Heritage advice, former Kongwak Butter & Cheese Factory

Heritage impact assessment

Kongwak Butter & Cheese Factory

Final – 14 June 2023

Figure 2 – Extract of demolition plan showing the proposed internal changes to the former cheese factory. The changes outlined in green are illustrated in Figures 3 and 4.

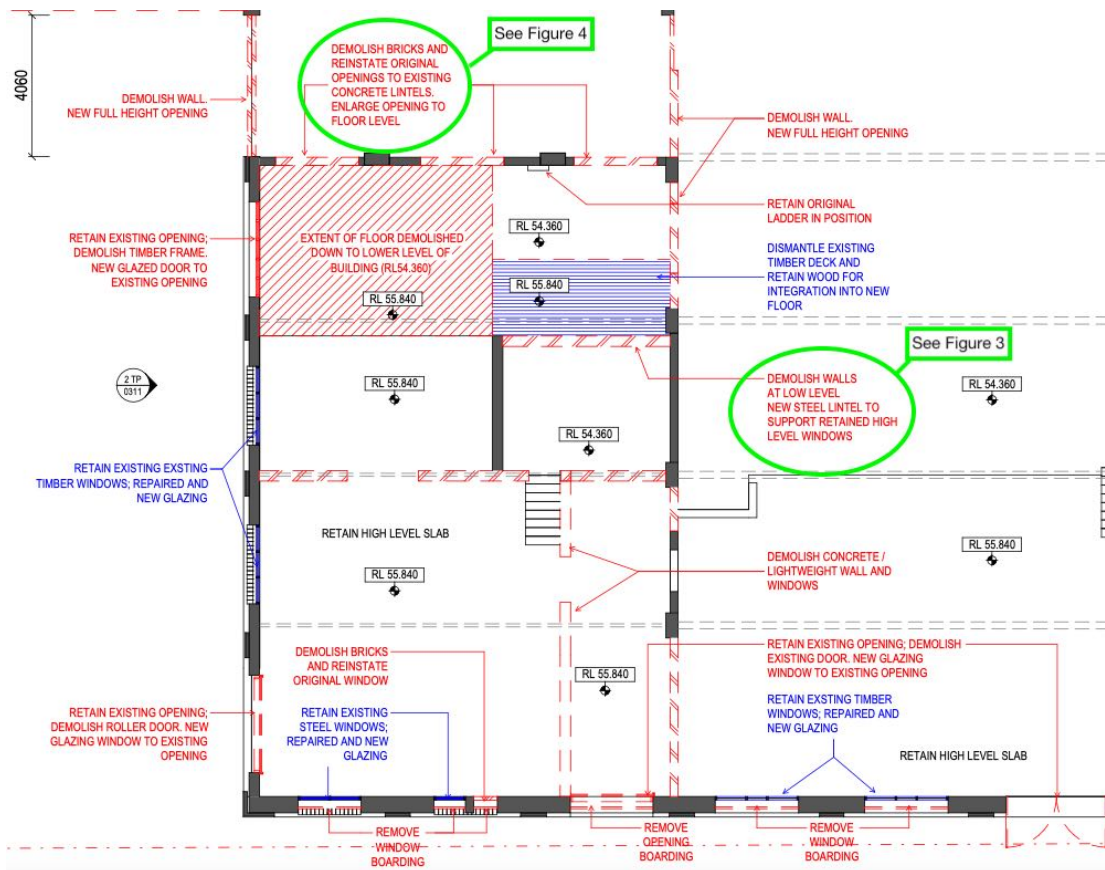
- Representative sections of the original walls and glazing and other details will be retained, enabling the original spatial arrangement and layout to be understood and interpreted. See Figures 2, 3 4, and 6, which illustrate how this will be done.

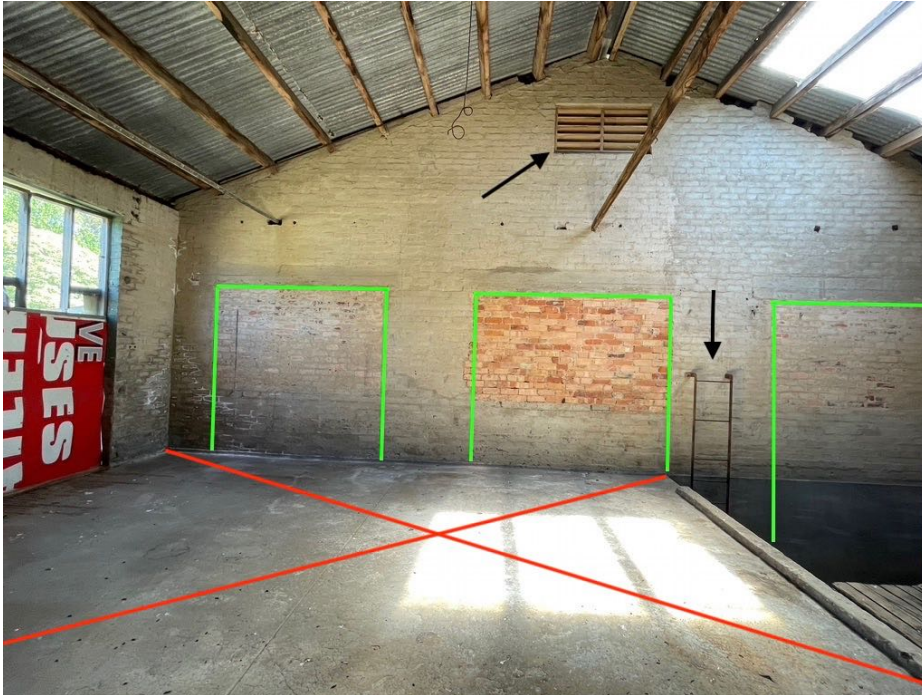
Figure 4: The three original window openings (bricked in later) outlined in green will be reopened and extended to floor level (the section of floor marked in red will be lowered to match the level of the lower floor at right). This will enable the staged development of the factory to be interpreted. Original features indicated by the arrows including the louvred vent and the ladder will be retained.

Figure 5: Top: c.1920s/30s image of the former butter factory showing the original openings in the east and front elevation (indicated by added red arrows) that will be reinstated. The lower image shows the original door to the front opening that survives and will be retained.

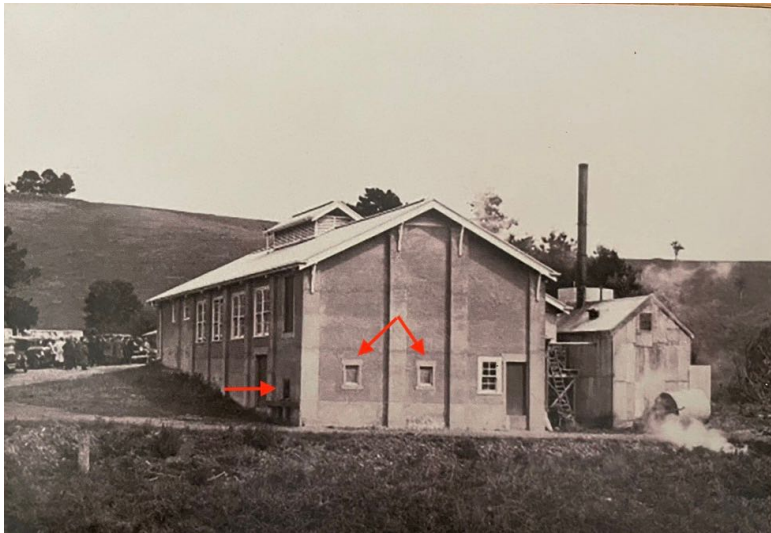
- There are no new openings in the principal facades of the buildings. Where openings are created, they are to allow reinstatement of original windows.

Figure 6: Original coolroom door at left and hexagonal tiles at right, which will be retained.

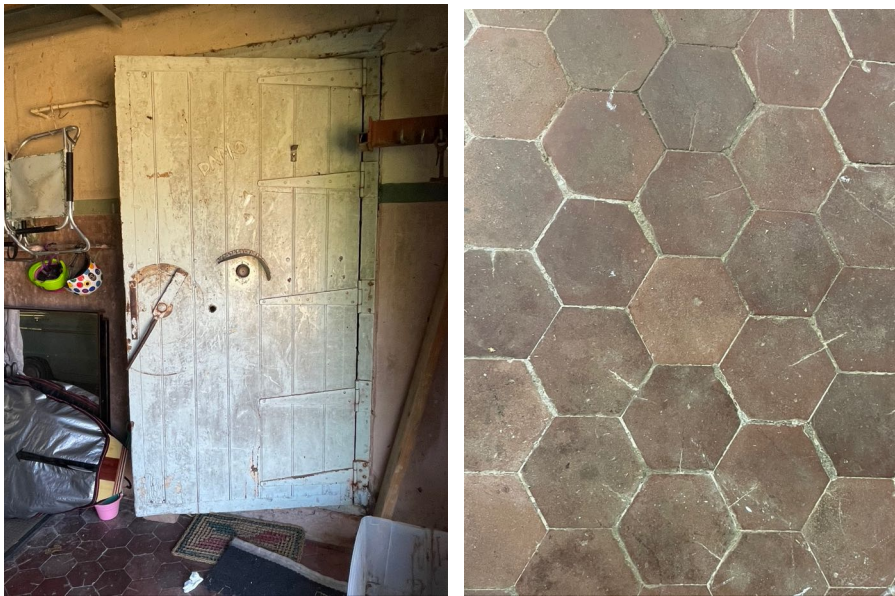
- While alterations are proposed to the layout of internal walls of the former cheese factory, enough fabric will remain to ensure the original spatial arrangement of this area as a series of discrete rooms can be interpreted. As illustrated in Figures 3 and 4, this includes the retention of an original wall ladder (enabling the original change in floor level to be understood), and reinstatement of timber deck materials in the same location, but at a lower height, to indicate the original location.
- In the former butter factory, the original double-height volume to the eastern half of the building will be restored. While one original wall in this space will be removed, this will be interpreted by the change in level and the retention of the original coolroom door. The important original hexagonal floor tiles will be retained within this space (Figure 6).
